VARIANCE APPLICATION

PROPERTY INFORMATION			
Project/Property Address: 213 Camrose Ct		Project Name/Business Name: Woodside Green Parking Lot Replacement	
Parcel #: 025-006520	Zoning: (see Map)	PUD	Acreage: 32.22

Zoning File No. **V-0166-2022**

PLANS TYPE FOR
**WOODSIDE GREEN PARK
 PARKING LOT IMPROVEMENTS**
 213 CAMROSE COURT
 GAHANNA, OH 43230

CONSTRUCTION DOCUMENTS FOR
**WOODSIDE GREEN PARK
 PARKING LOT IMPROVEMENTS**
 GAHANNA, FRANKLIN COUNTY, OHIO
**GRADING, UTILITY, &
 EROSION CONTROL PLAN**

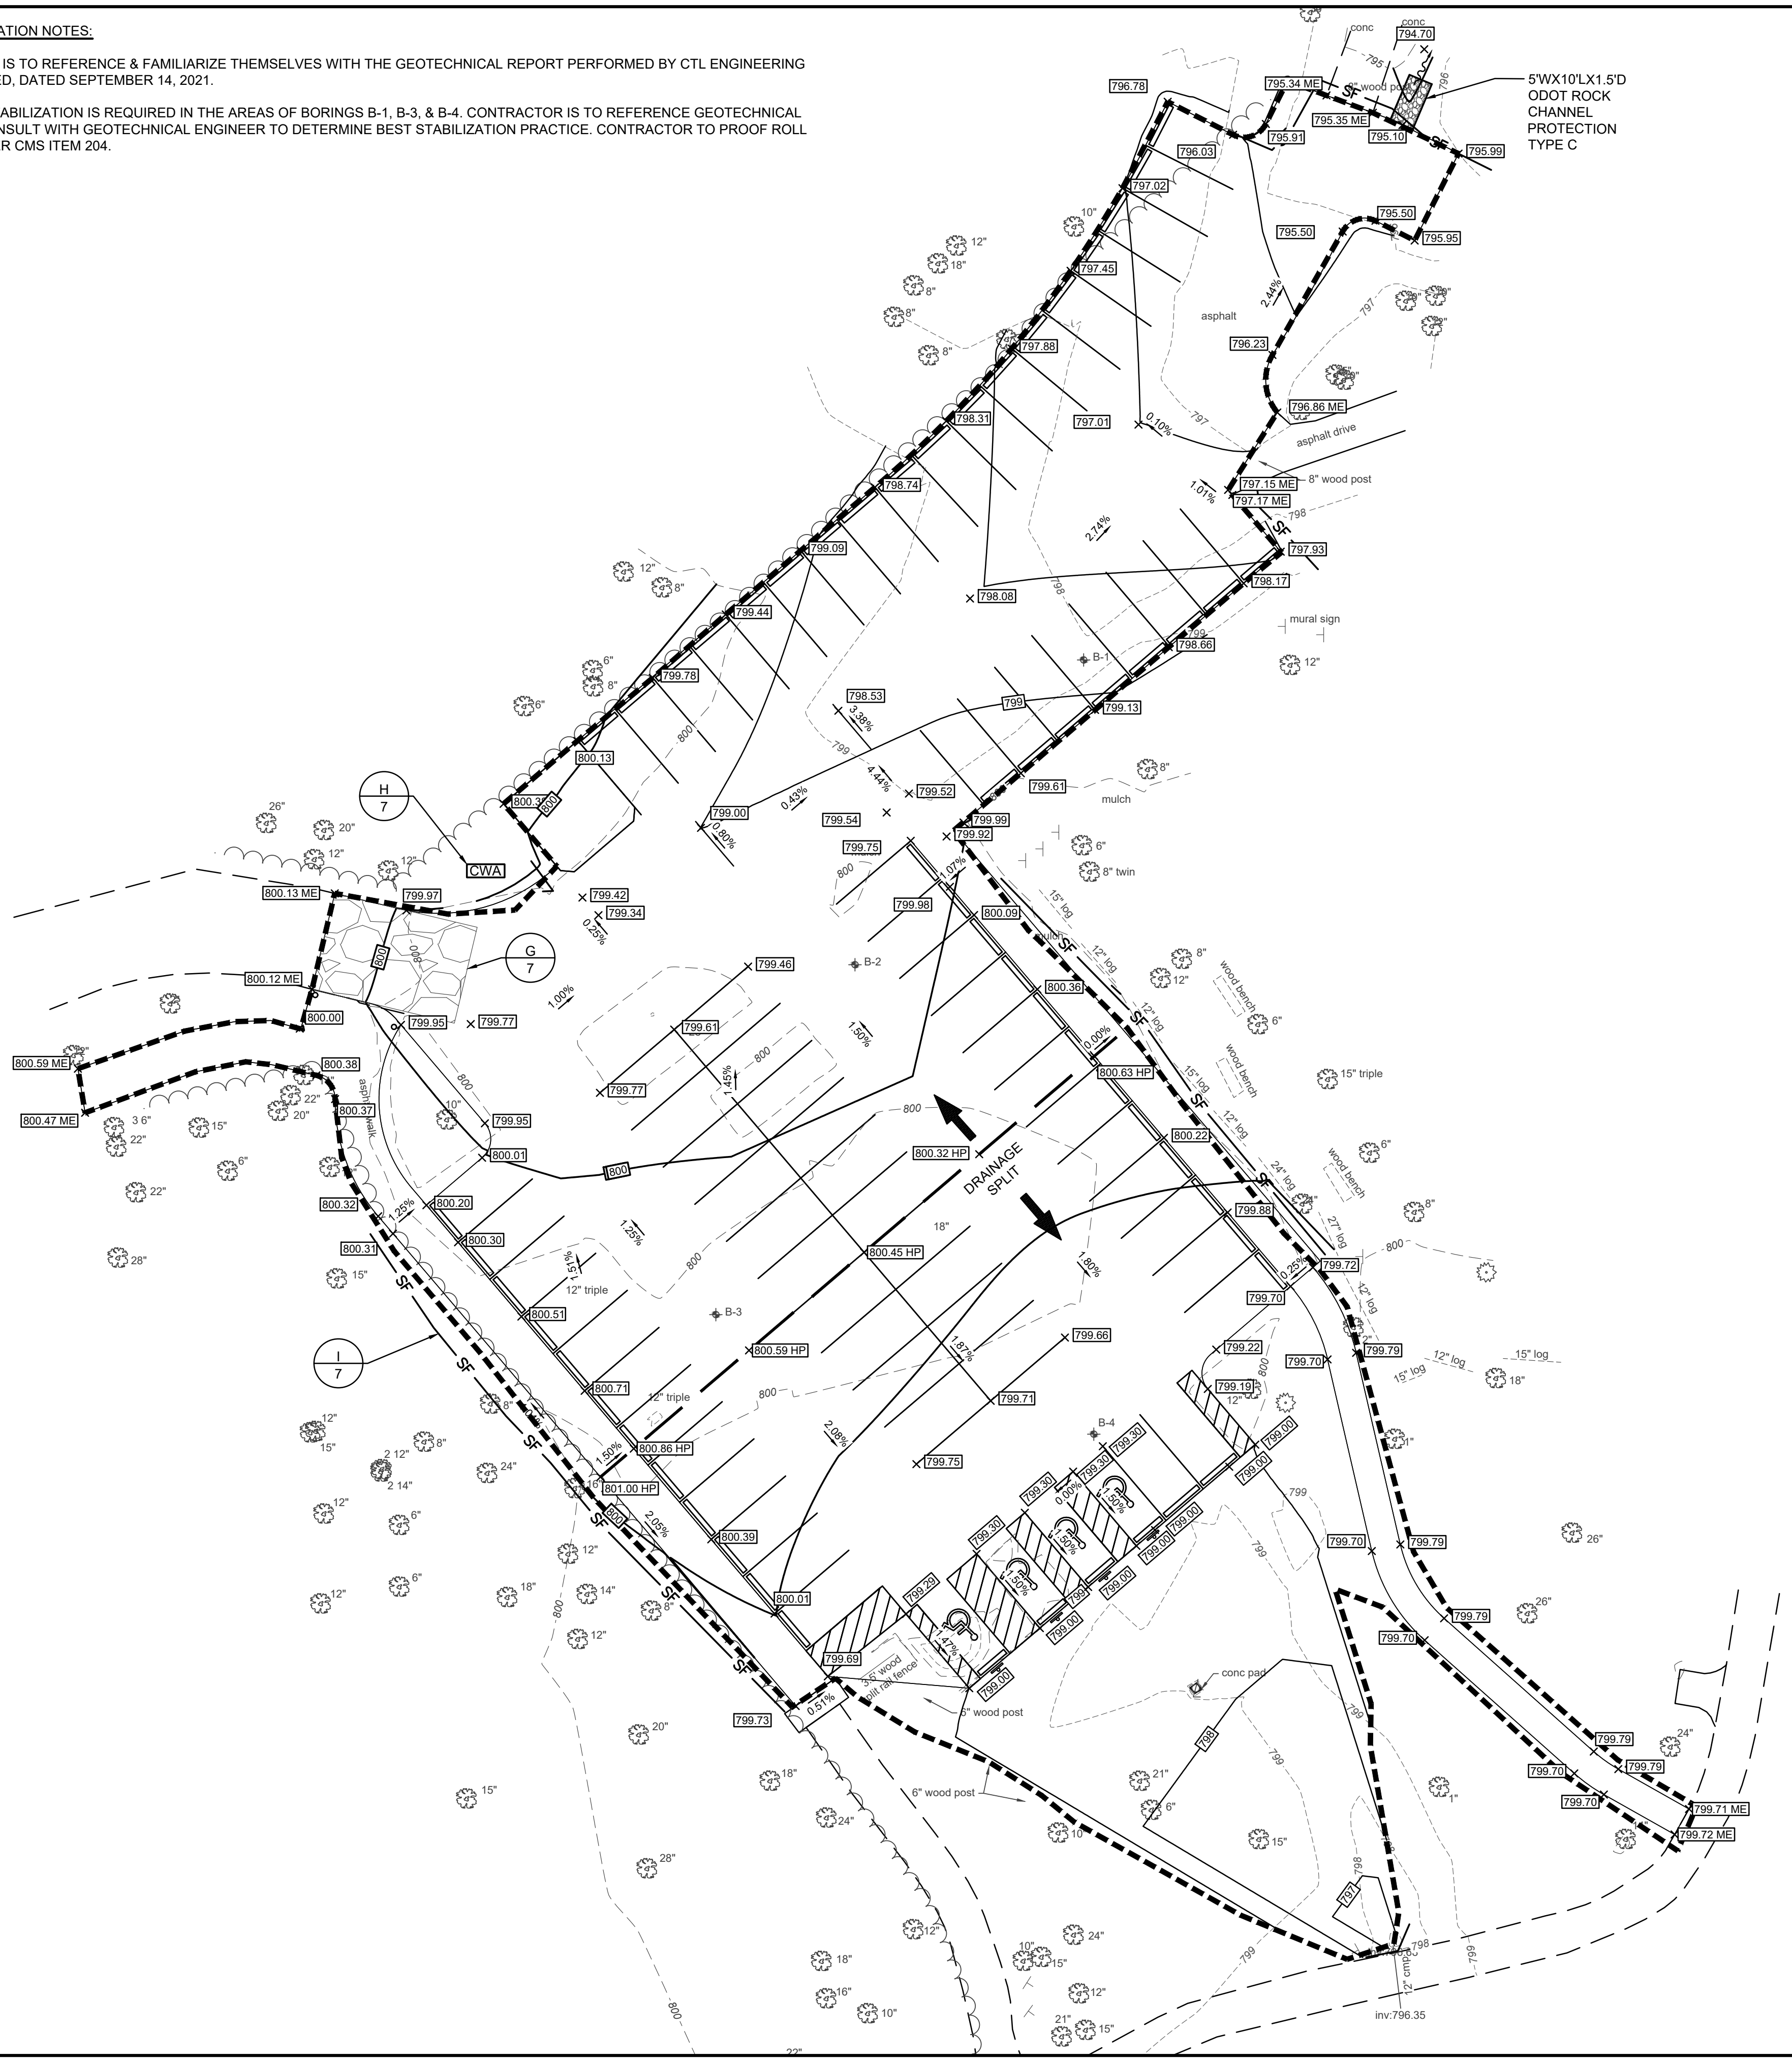
"Section 1163.08(h) requires a 10ft wide, 3ft high screened island between rows of parking. The proposed parking layout does not meet this requirement. A variance may be requested."

The parking lot is situated in one of Gahanna's oldest and most densely forested parks. In addition to the modest entrance island, the parking lot is surrounded by rain gardens, landscaping beds, Big Walnut Creek riparian corridor, and native shade and understory trees. In the effort to maximize parking spaces and, subsequently, resident and visitor access to the natural areas, Gahanna Parks & Recreation respectfully requests a variance from 1163.08 requirement to provide internal parking lot trees and parking islands.

New parking (17 spots)
 Interior Landscaping
 Park Space/ Trees

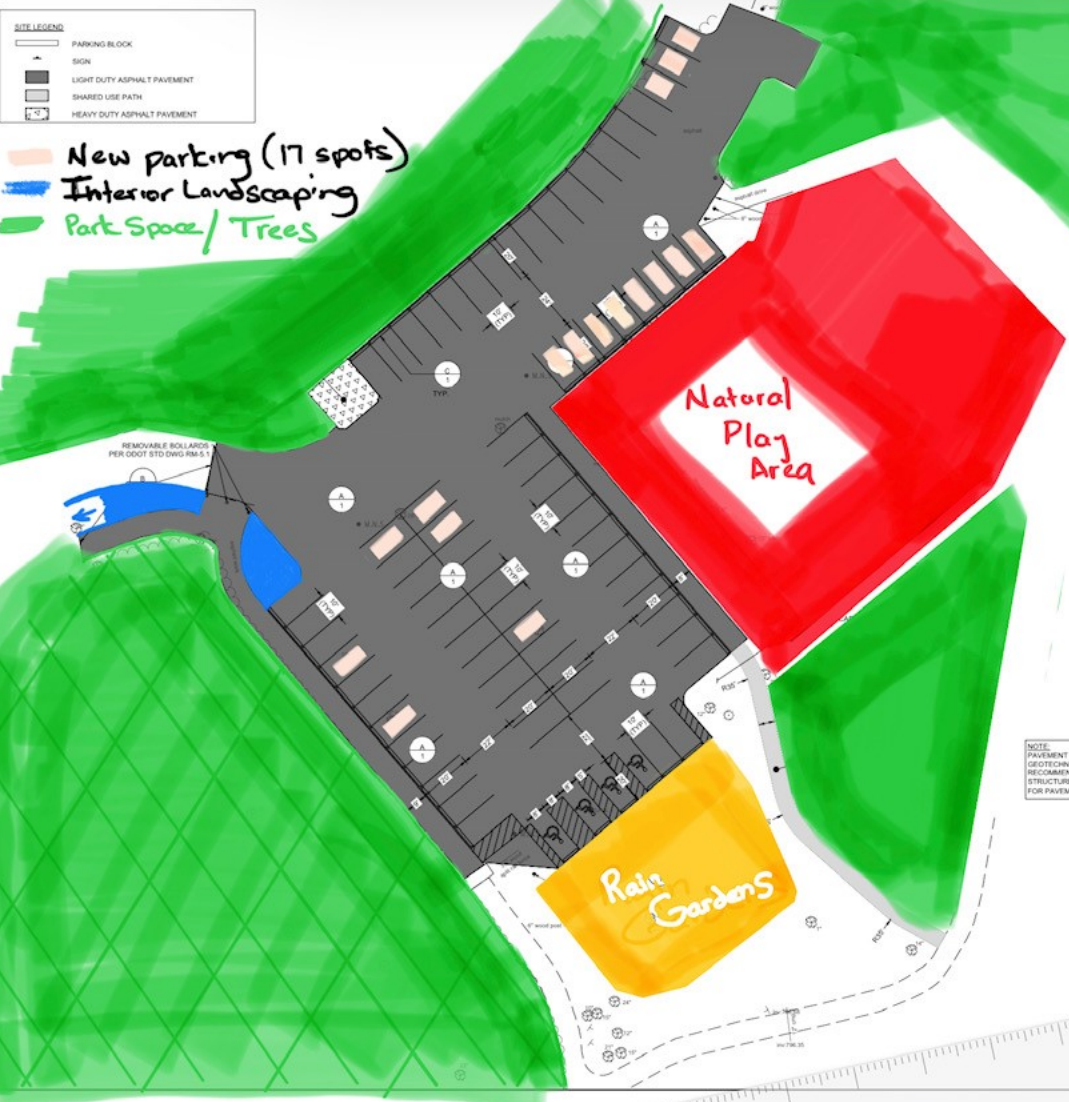
5. "Section 1163.08(c) requires a minimum of 5% of the total area of the parking lot pavement to be interior landscaped area. Provide a calculation on the plan sheets to verify this requirement is met and identify any interior landscaped areas."

6. *"Please provide details on the plan to show compliance with all requirements in section 1163.08(e) including landscaping area, parking lot trees, and any parking islands."*

The overall paved area of the project is 31,857.5 Sq Ft

We are adding 17 new parking spots (300 ft² each). 5100 square feet in total. 5% (landscaping bed requirement) of 5100 is 255 square feet of required new landscaping beds. One tree per 100 feet of landscaping bed requirement is 2.5 new trees. I met with the City of Gahanna Forester and she is planning to add 4-5 trees to the entrance bed as part of the parking lot project, therefore we will no longer be seeking a variance for 1163.08(e).
